Item 4.**Development Application: 15-17, 19-21 and 23 Hunter Street and 105 and 107 Pitt Street, Sydney - D/2023/1045****File No.:** D/2023/1045**Summary**

The proposal seeks consent for site excavation, remediation and the construction of a 55-storey mixed-use commercial and retail development with associated basement parking and retail uses, a through site link, the restoration of the existing heritage item on site and commercial office uses.

Figure 58: Proposed tower, with approved envelope shown in blue

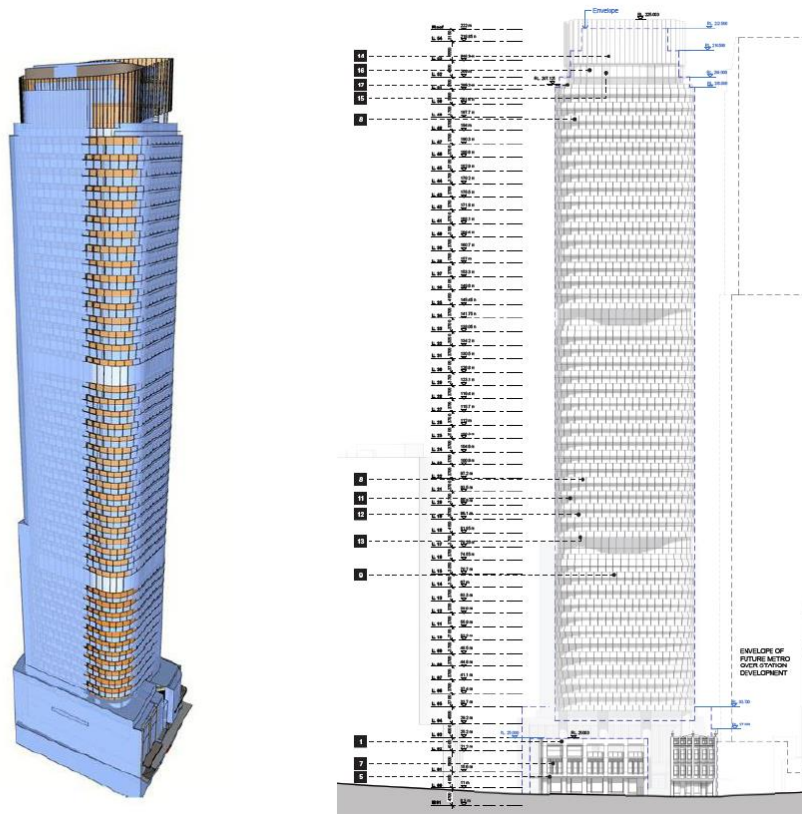
- 67. The proposed development is largely within this envelope, except for two proposed areas of the tower at the south-eastern edge of the tower form and the crown as shown in Figure 58 below.

Figure 59: Chamfered tower above the podium compared to approved envelope

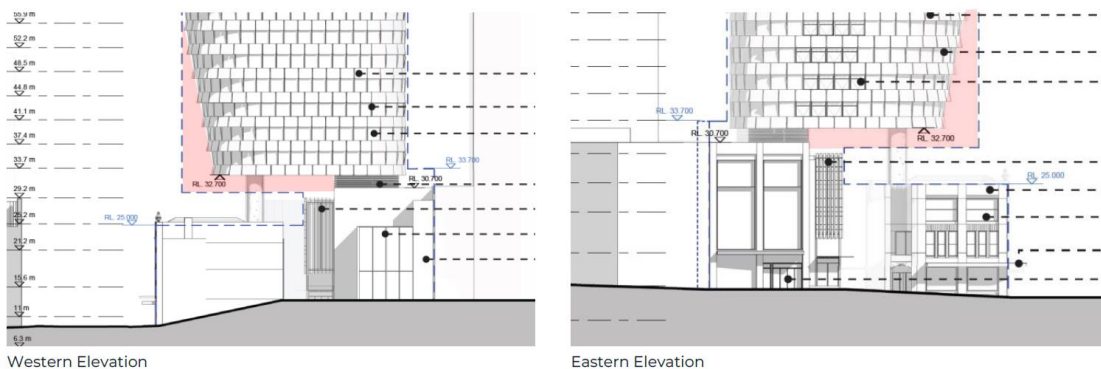
68. It is noted that the podium is entirely consistent with the envelope, with additional chamfering of the tower proposed to allow for added light into the through site link. A significant portion of envelope area is unfilled in the lower levels of the tower envelope, articulating this portion of the tower. Figure 59 demonstrates this additional area of envelope provided.

Figure 60: Nature and extent of DCP envelope variation

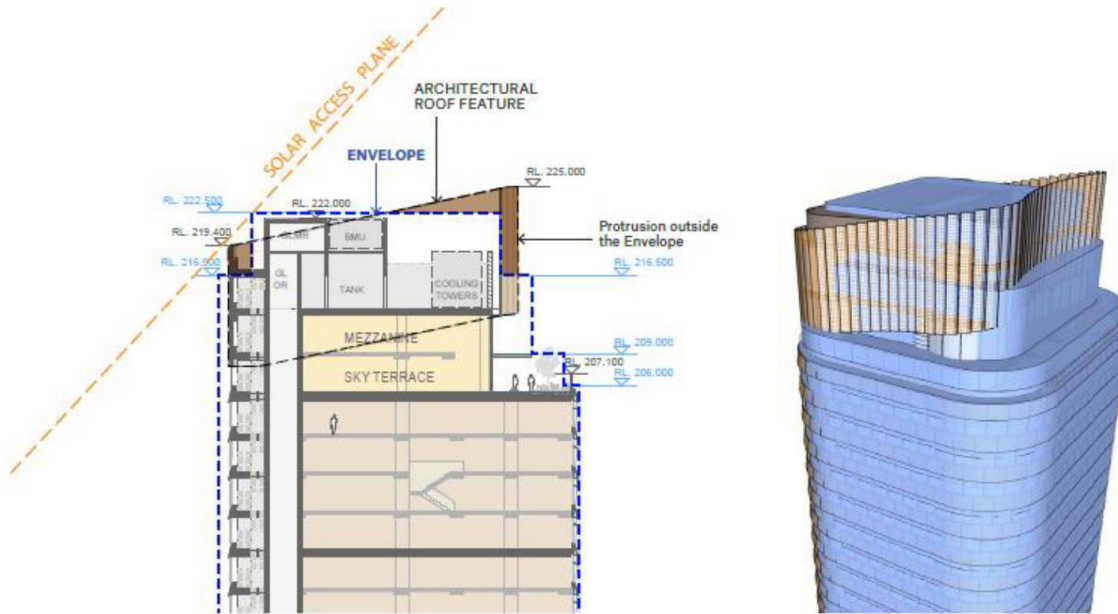
69. Under section 6.3.26 of the SDCP, a height of RL 222.5m AHD is referenced for the envelope. The proposed development is generally consistent with this height, except for the architectural roof feature of the Crown, which is to be provided above the top-level plant.

70. The architectural roof feature will extend to a height of RL 225m AHD. The tallest part of this roof feature is localised to the northern part of the site, with the Crown remaining below the Martin Place Sun Access Plane. The top of the building is expressed as an articulated screen with solar panels, housing an open top plant room as illustrated at Figure 60. The overall Crown is presented as a single, integrated architectural roof feature, providing a cap to the building and a distinctive addition to the skyline.

71. The extent of variation at this upper level is considered negligible and is supported. The crown has been designed in a way to provide a bold topper to the building, appropriately concealing building services while also ensuring solar generation through the provision of PV cells. It is a decorative element at the top of the tower that contains no floor space or signage.
72. Further, the crown will not result in significant overshadowing and will maintain compliance with the Martin Place Sun Access Plane and given the exceedance of the envelope is only minor, further analysis on wind impacts or daylight access in addition to what has already been undertaken during the Planning Proposal process is not deemed necessary.

Figure 61: Envelope plan demonstrating sun shading beyond the envelope

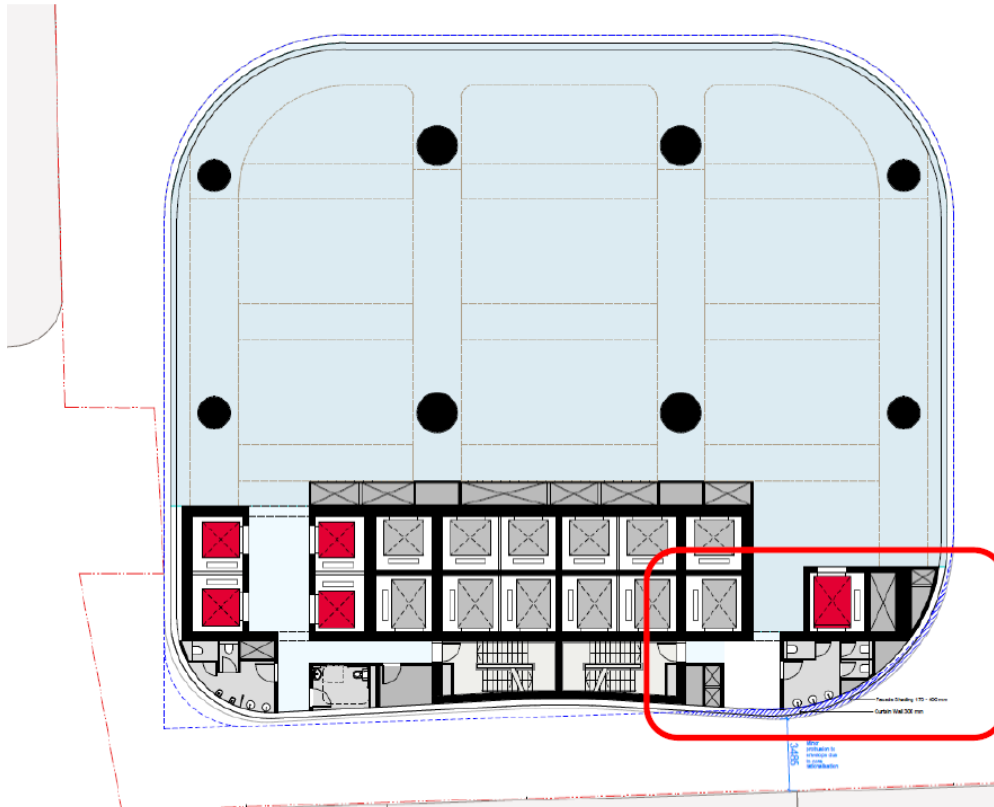
73. Design development following the design competition has resulted in the rationalisation of the core and the reshaping of the southern façade to create a more consistent expression, straightening and aligning the two southern corners. As a result, the sun shading on the south-eastern corner slightly encroaches beyond the envelope on the south-eastern corner. This encroachment is limited to approximately 700mm in depth as shown at Figure 61. The change also has the benefit of opening views to the south-eastern corner of the site and south down Pitt Street, as requested by the Jury through the design competition.

74. This minor departure from the DCP envelope is considered acceptable for the following reasons:
- (a) The proposed building form and envelope achieves the objectives of section 6.3.26.1 in that:
